Amendment, Permit # B23001364

Clarification of revision to B23001364 for the addition of a plumbing rough-in for new detached garage/workshop for Heath Department.

Building Permit B23001364 modification for electrical and plumbing rough-ins

Garage Floor Plan

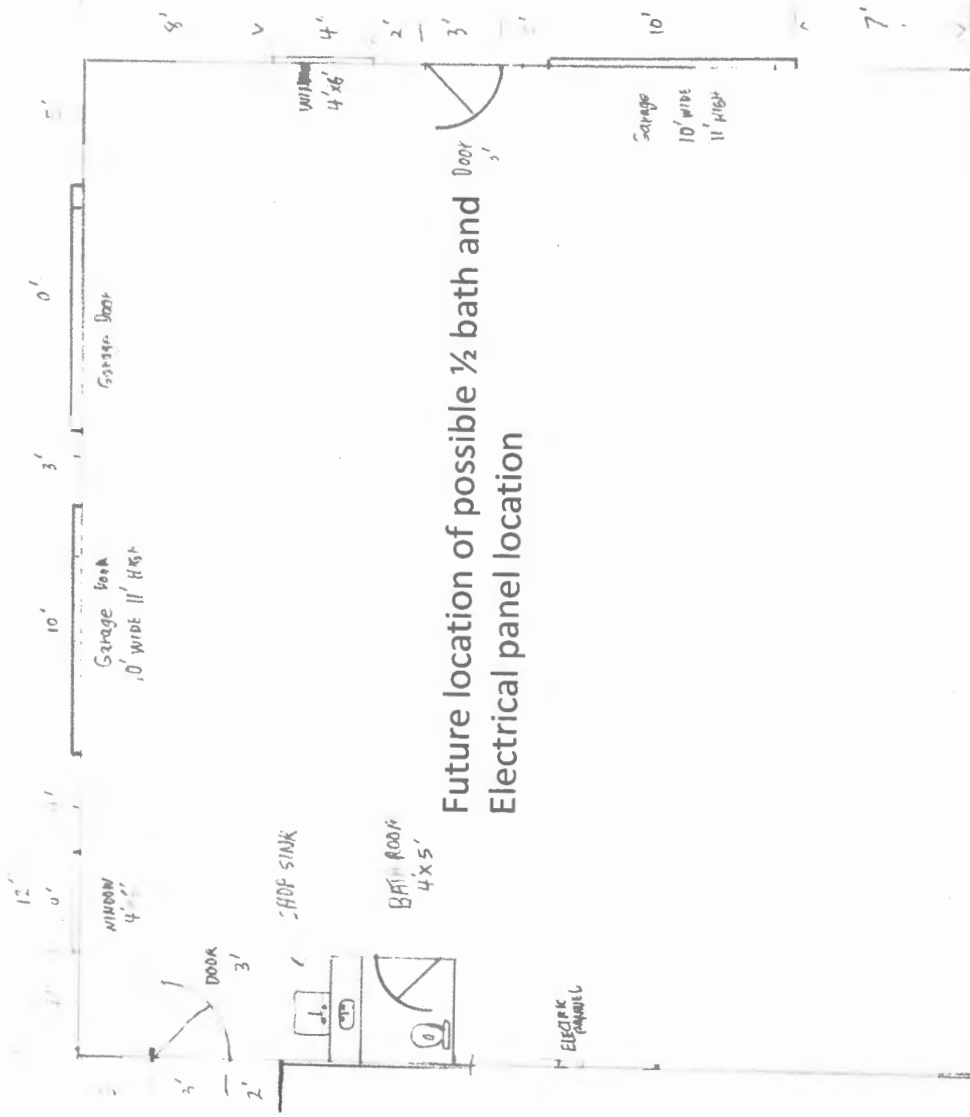
Concrete contractor installing footer recommended doing rough-ins for Electric service line and ½ bath for future use before pouring concrete floor.

Future location of possible 1/2 bath and
Electrical panel location

Rough-in Electric line under new Garage floor

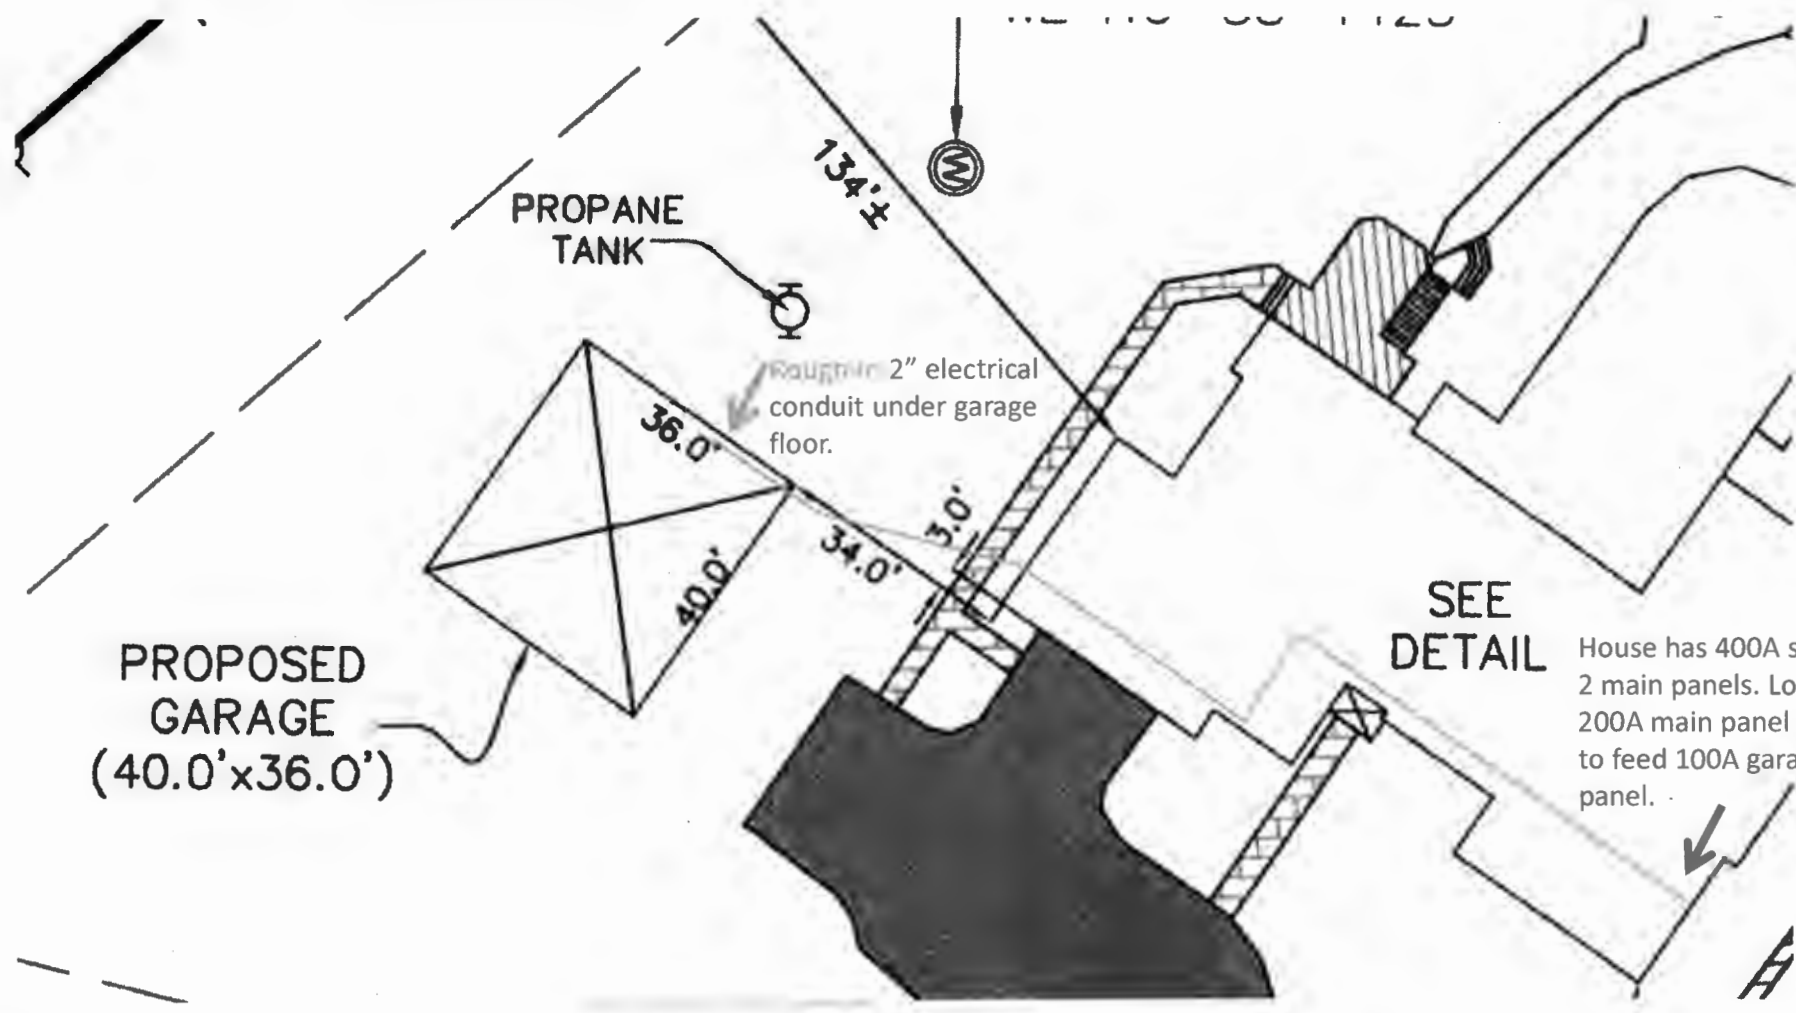
When I built my house in 1991 a main 4" septic line (see new diagram below) in dark blue was run from the septic tank under the full length of the house. All plumbing in the house tees off this line under the basement floor. At the end of the main 4" line, an elbow connects to a 4" cleanout stand pipe that comes up 12' to the surface (walkout basement on 2 sides of house). The stand pipe is located about 12" outside the poured concrete basement wall of the house. The dirt around the stand pipe will be excavated to a depth of about 6 feet (to provide the ¼" per foot fall for the 66' run to new garage) to insert a new tee that will connect to the new 4" septic line that runs under the new garage floor.

Rough-in 2" electrical conduit under garage floor.

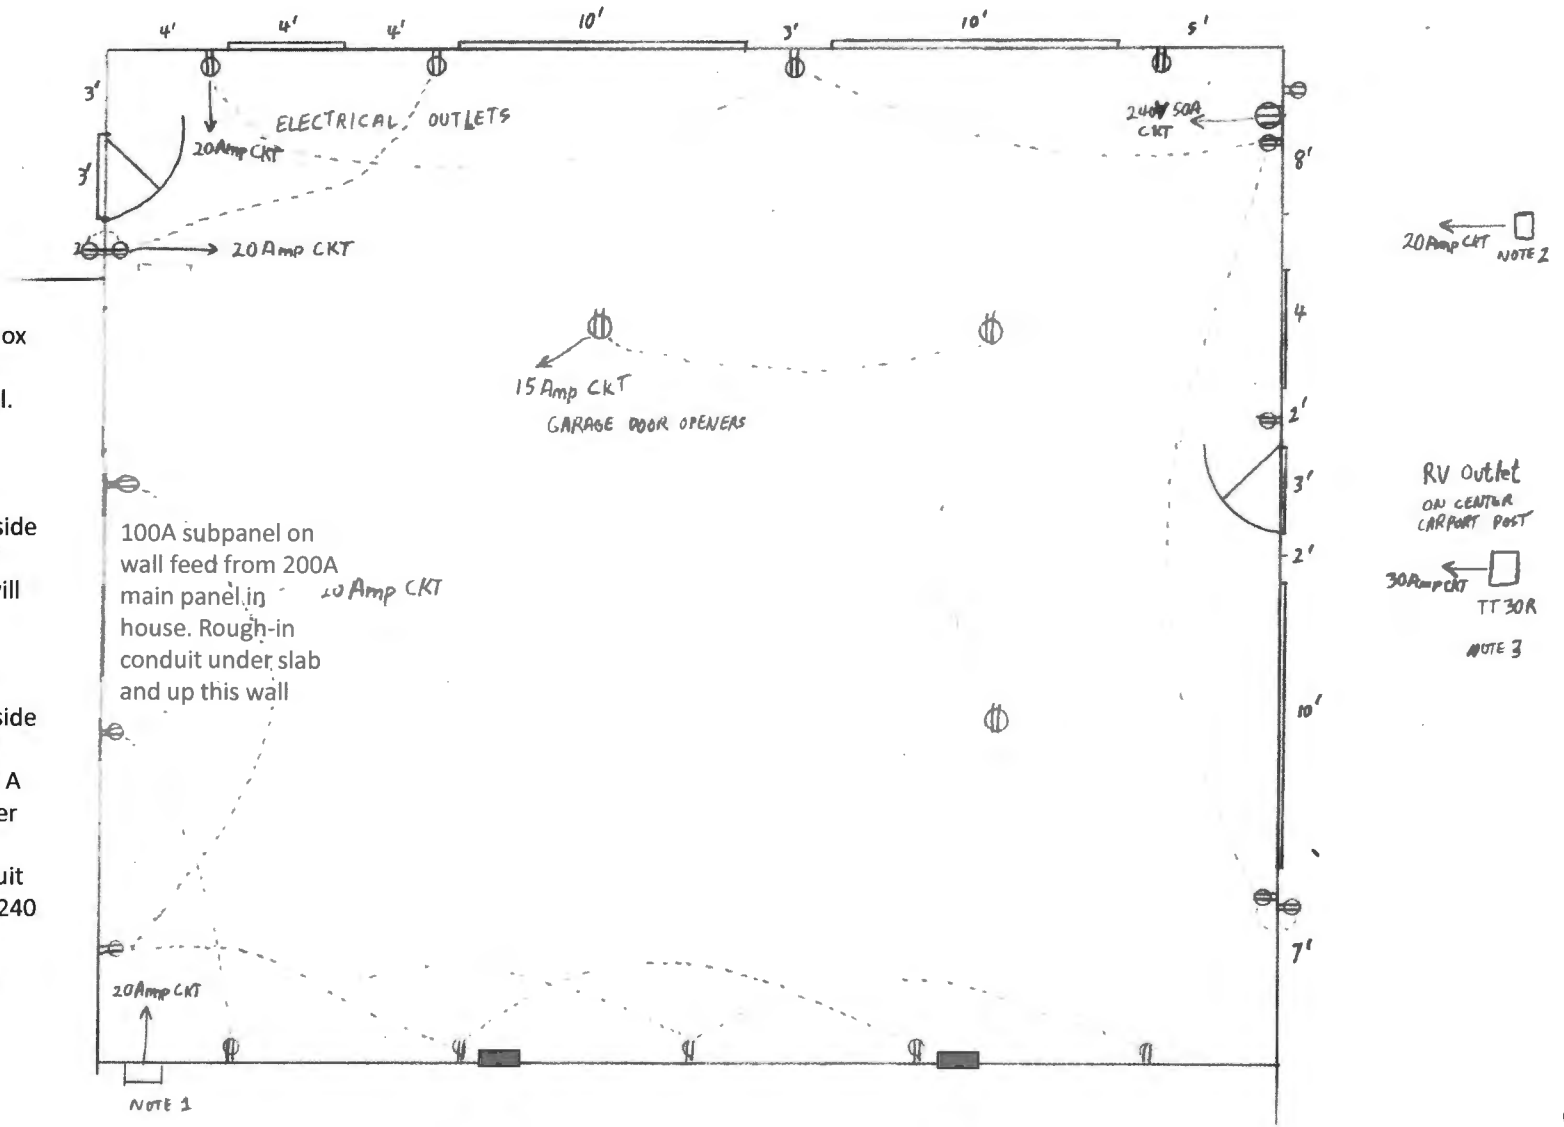
House has 400A service with 2 main panels. Location of 200A main panel with space to feed 100A garage sub panel.

- Note 1: 1" conduit to 6" weatherproof box on exterior of brick back wall of garage mounted at least 12" above ground level. Exterior weatherproof duplex outlet connected to box.
- Note # 2; 1" underground conduit to 6" weatherproof box mounted on post on side away from garage, mounted at least 12" above ground level. (future use of box will be to extend underground conduit for electrical outlet by parking pad.)
- Note # 3; 1" underground conduit to 6" weatherproof box mounted on post on side away from garage, mounted at least 12" above ground level. Will connect to a 30 A socket (TT30R) for plugging in a RV/Trailer
- Note # 4: locate two empty boxes evenly spaced in back wall with 1" conduit back to breaker panel for future use for 240 V circuits (for future machine tools)
